**ERRATA SHEET FOR STANDARD SPECIFICATION BOOK FOR STATE  
ROAD AND BRIDGE CONSTRUCTION, EDITION 2007**

The Kansas Department of Transportation **STANDARD SPECIFICATIONS FOR STATE ROAD AND BRIDGE CONSTRUCTION (2007 EDITION)** includes:

Dimensions of the High Pressure Pipe Cleaning Nozzle.  
FHWA/RD-81/078

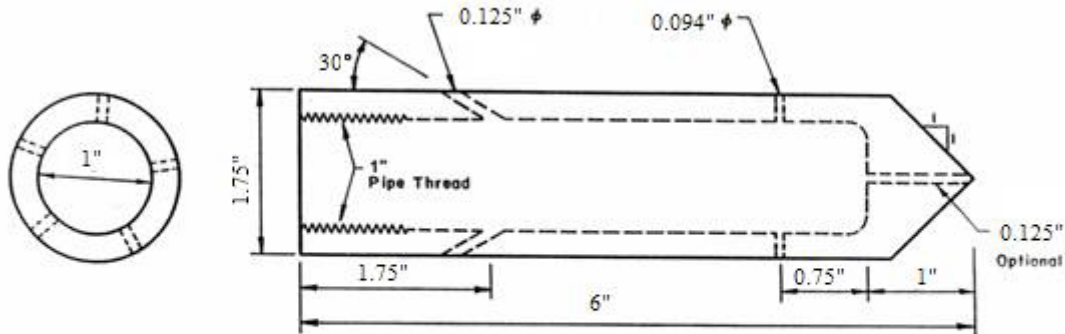
Page 800-100, replace FIGURE 845-1 with the following:
